TECHNICAL INFORMATION

TI2919

SiLine GF / GF X-Series

New narrow compartment

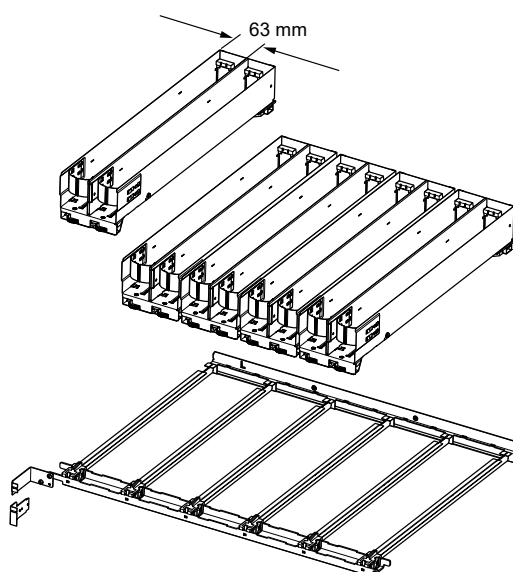
As we continually endeavour to improve our products we have introduced a new narrow compartment for the GF X-series and SiLine GF. This compartment has a maximum width per selection of 63mm which enables one more selection per shelf, for example 0.25l slim can or 0.33l sleek can. This increases both the product range and machine capacity.

By using the following conversion kits the number of selections per shelf can be increased:

Please note that the new narrow compartment is not supported by a software version earlier than the following:
